**LASELLS STEWART CENTER MECHANICAL & ROOF
RENEWAL**

EXHIBIT I – Alternate Narrative and Alternate Drawings

ALTERNATES NARRATIVE

A5.21A

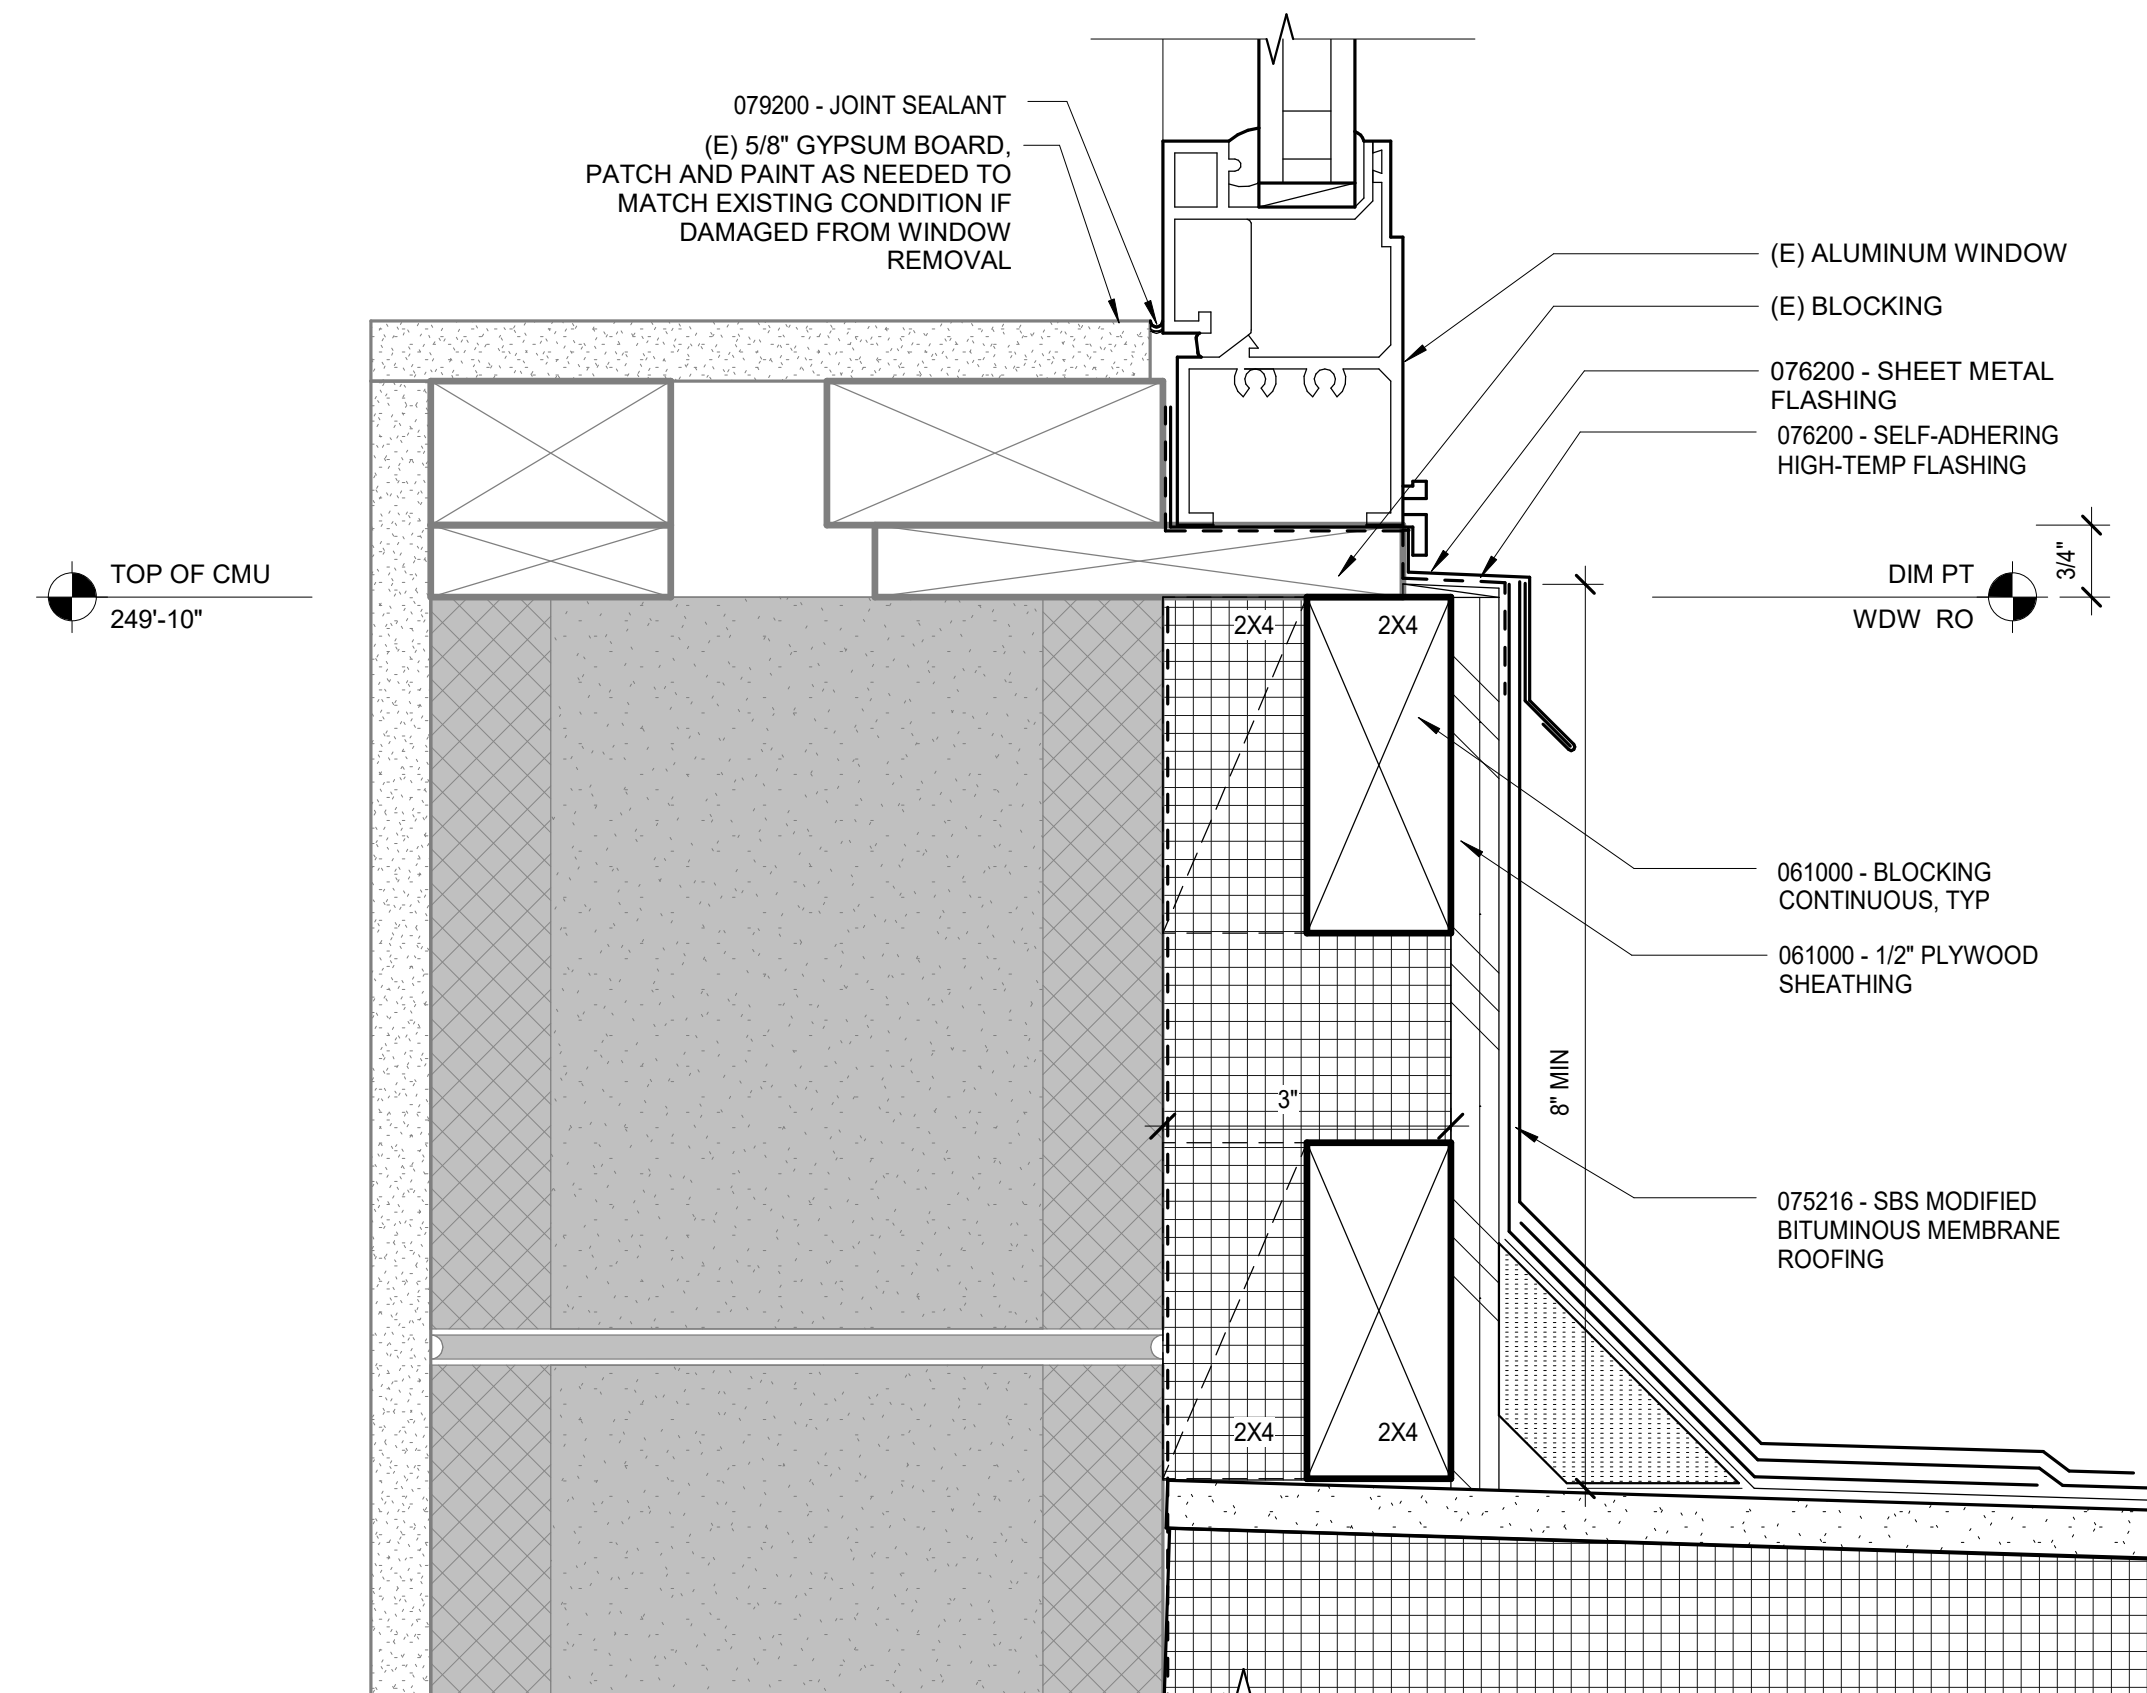
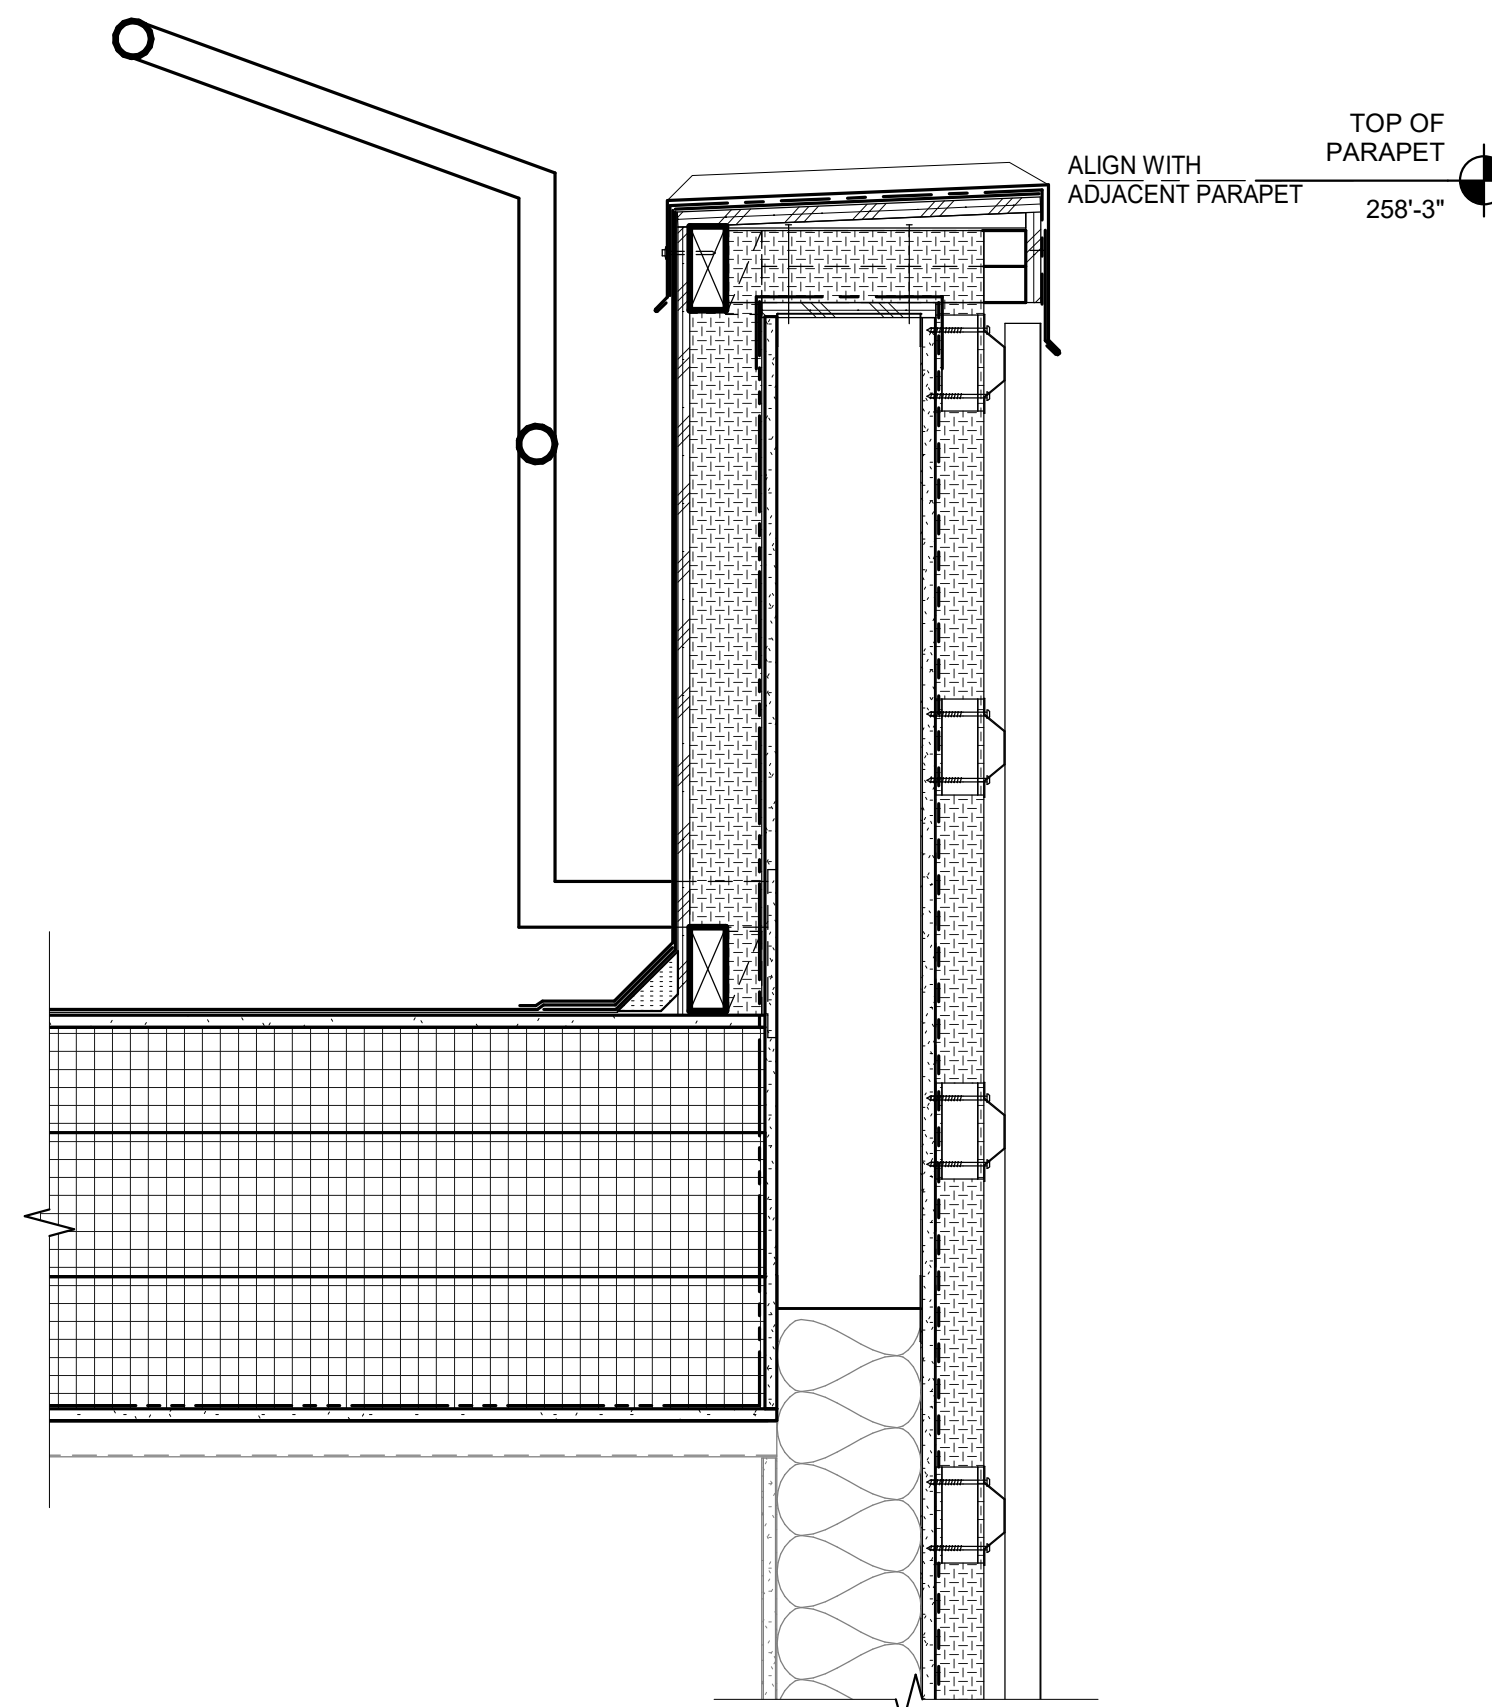
- A. General: Drawing Sheets referenced below are dated February 21, 2022:
- B. Sheet A5.21A – Exterior Window Details replaces details 1 and 2/ sheet A5.21.
 - 1. Alternate 1: Removes and replace existing window in modified window opening.

3 S PARAPET AT ELEC RM ROOF - ALTERNATE NO.5
1 1/2" = 1'-0"

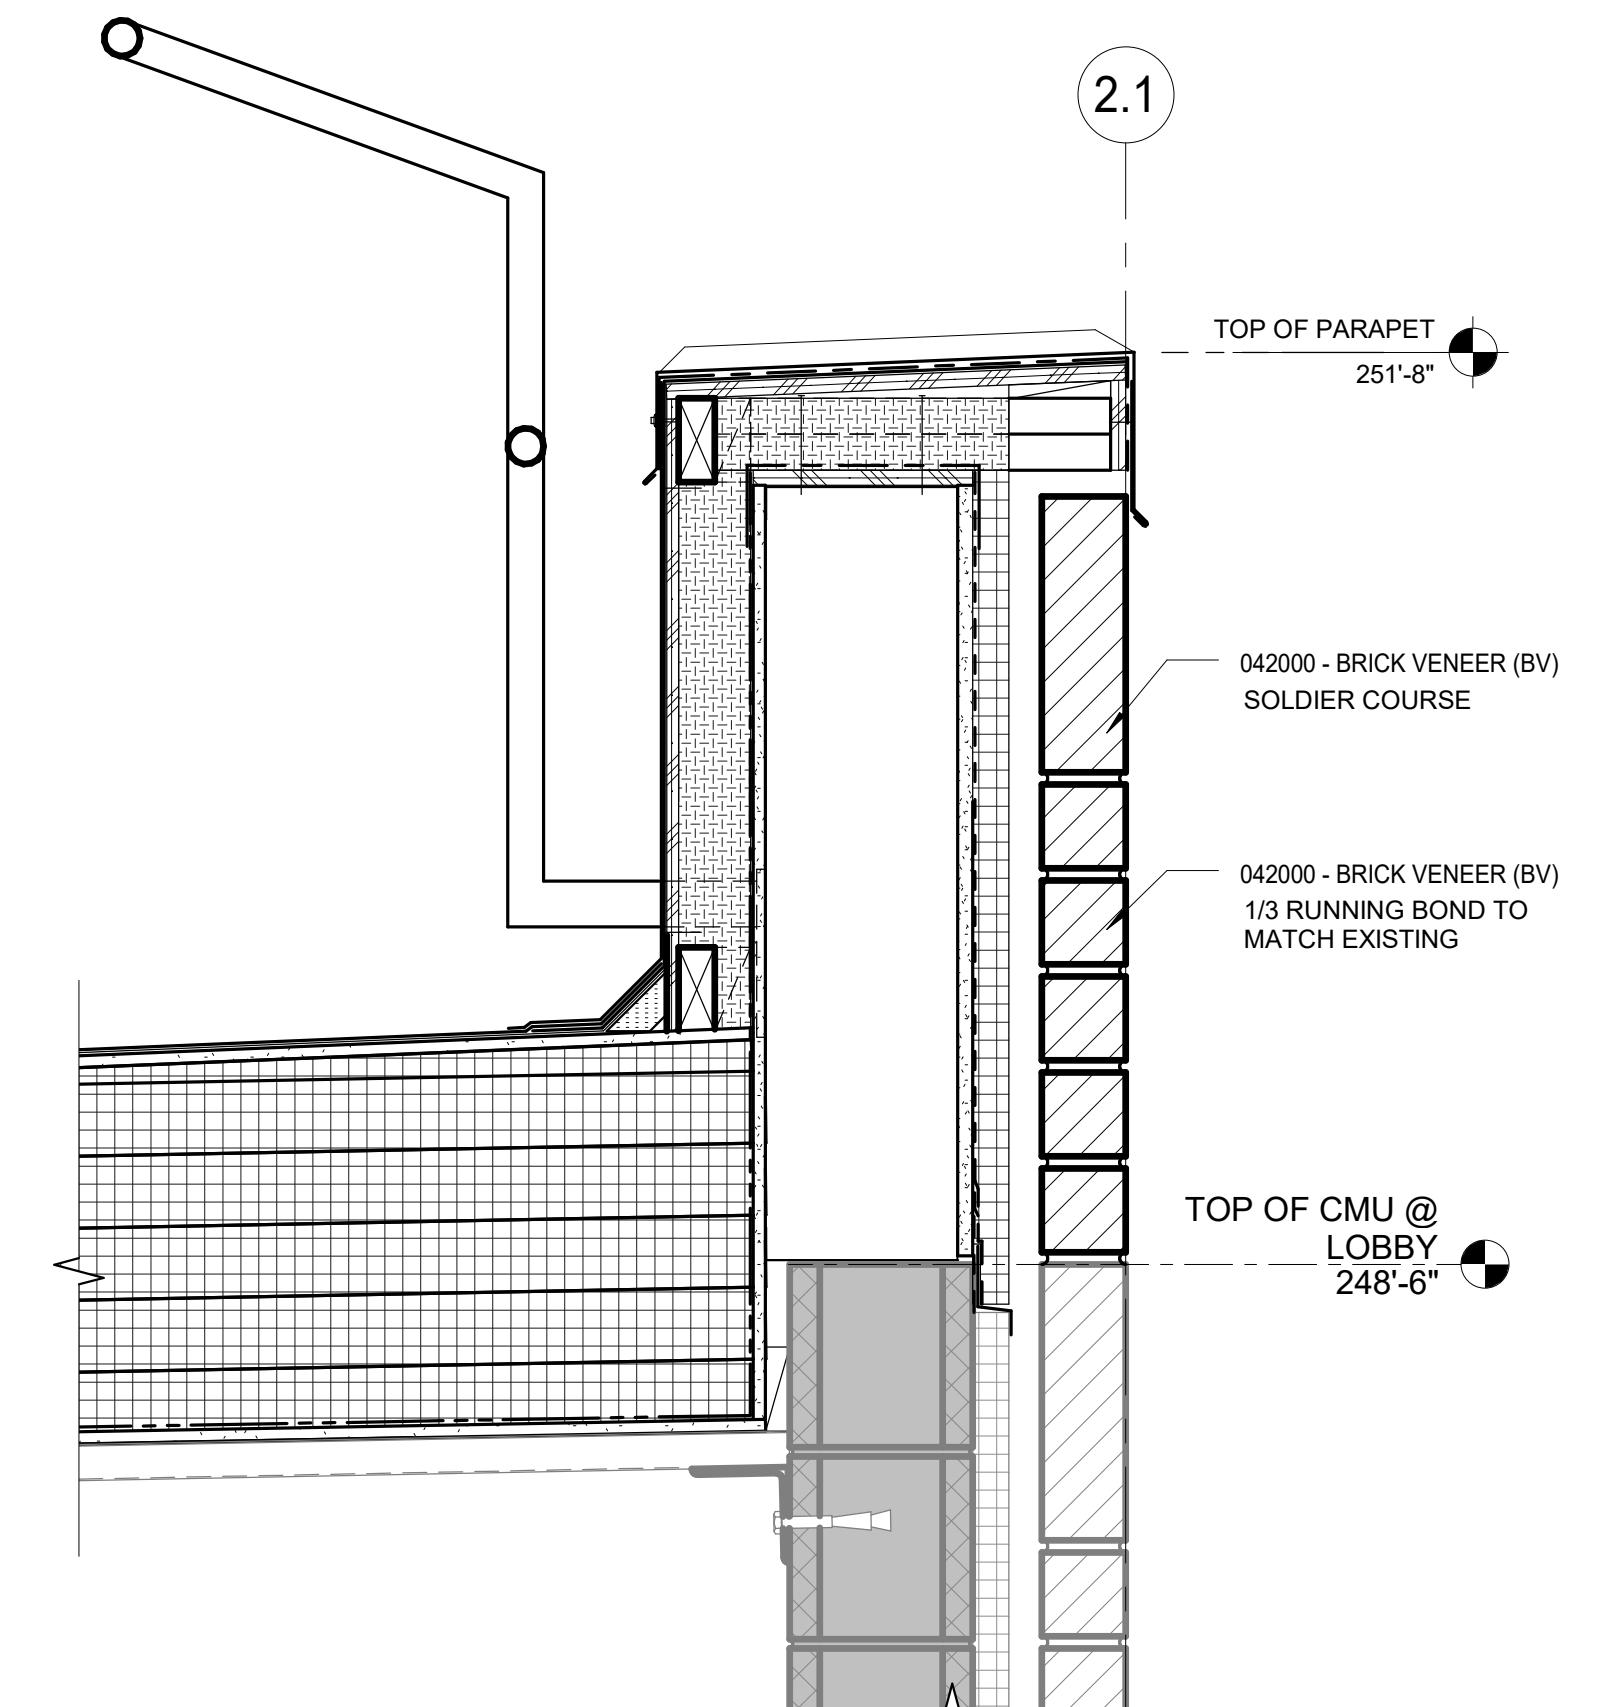
- C. Sheet A5.51A – Exterior Details:
1. Alternate 4: Detail 1/A5.51A replaces 1/A5.51 showing the increased height of parapet wall at Main roof.
 2. Alternate 5: Detail 3/ A5.51A replaces by Detail 2/A5.51 showing increased height of parapet wall at Electrical Room roof.

5 TYP STAIRWELL ROOF SECTION - ALTERNATE NO.7
3/4" = 1'-0"

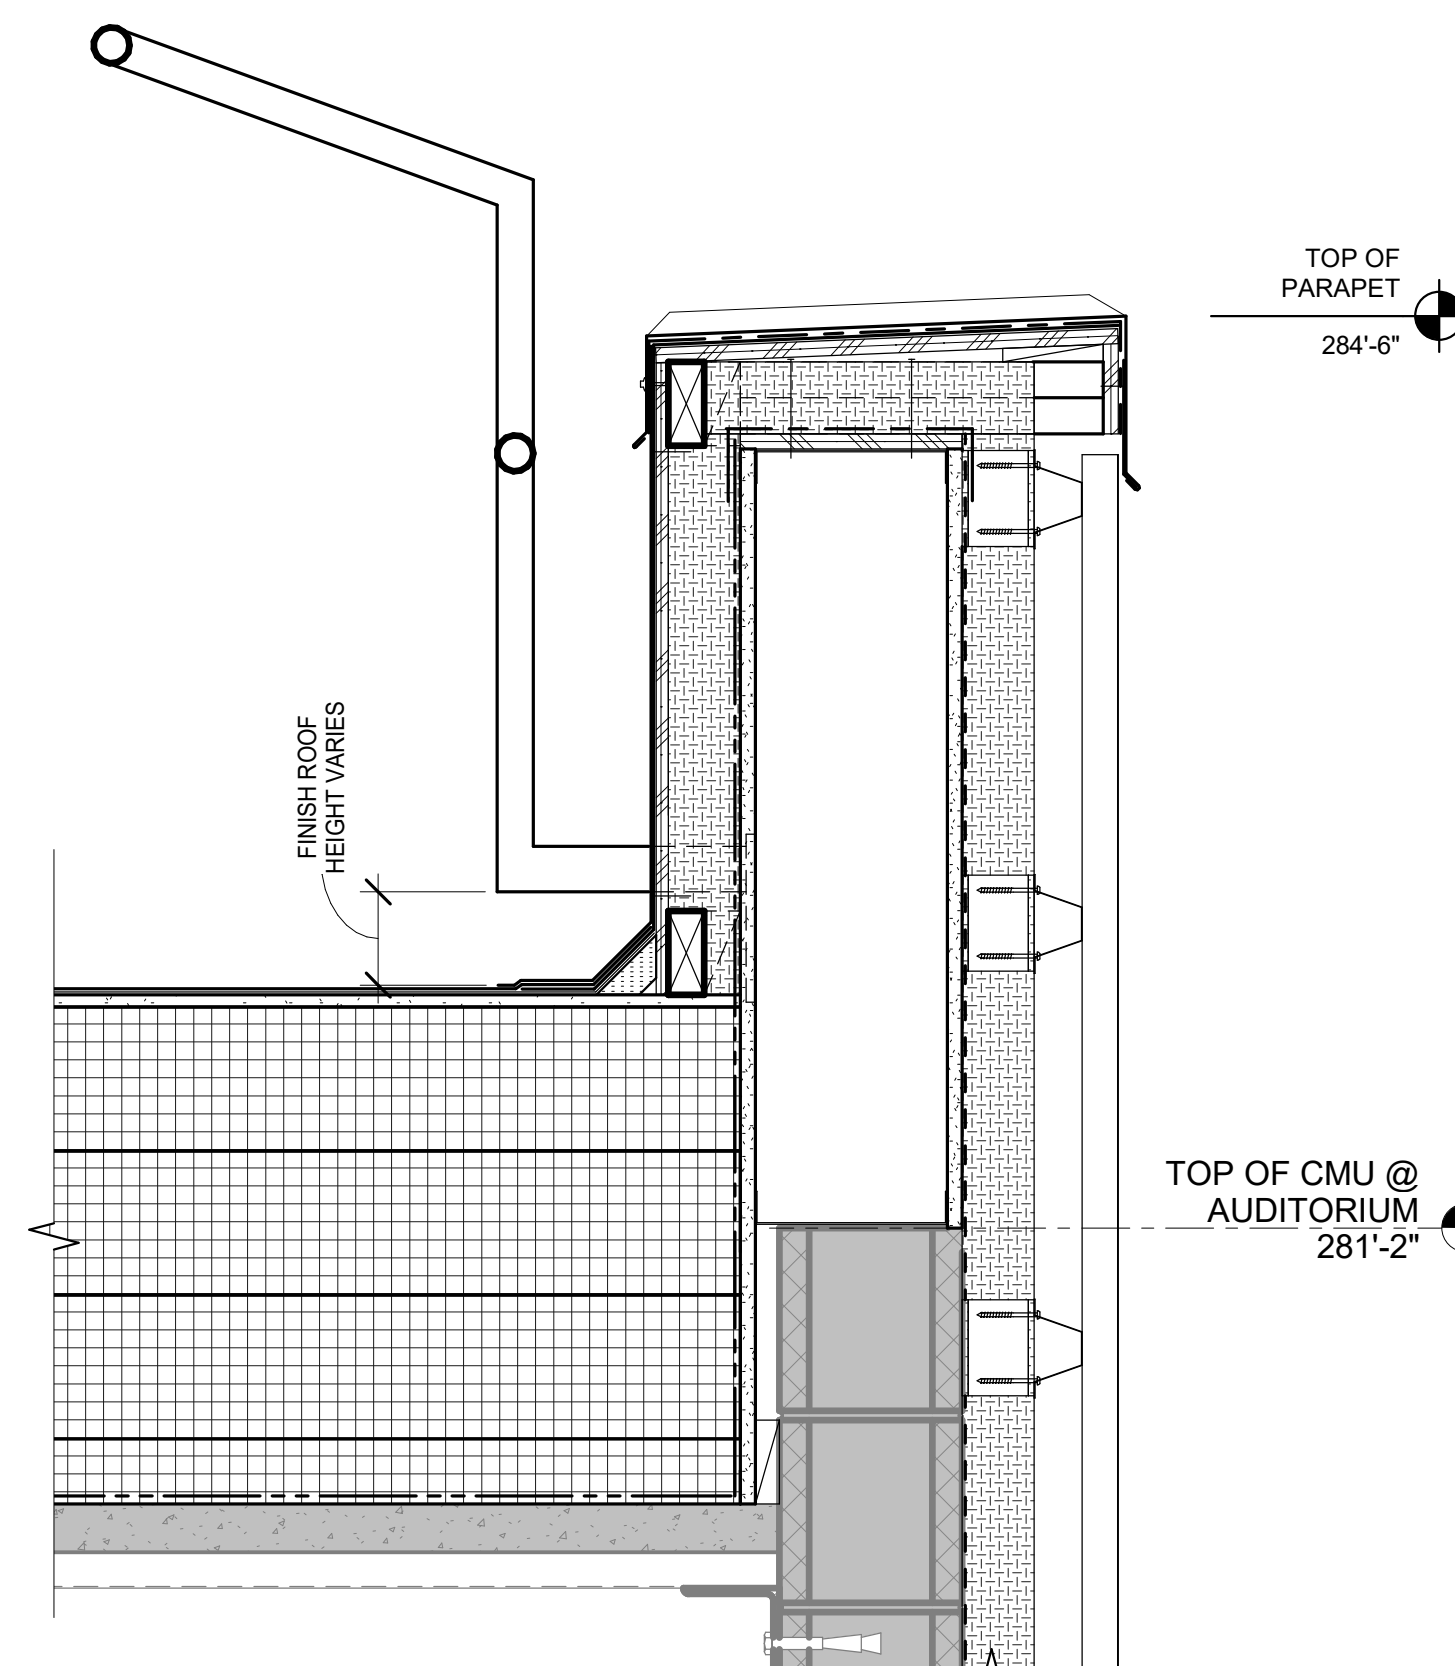
3. Alternate 6: Details 2 and 4/ A5.51A replace Details 1 and 2 A5.52 showing increased height of parapet wall at Auditorium.
 4. Alternate 7: Detail 5/ A5.51A revises parapet height at Stairwell roof.
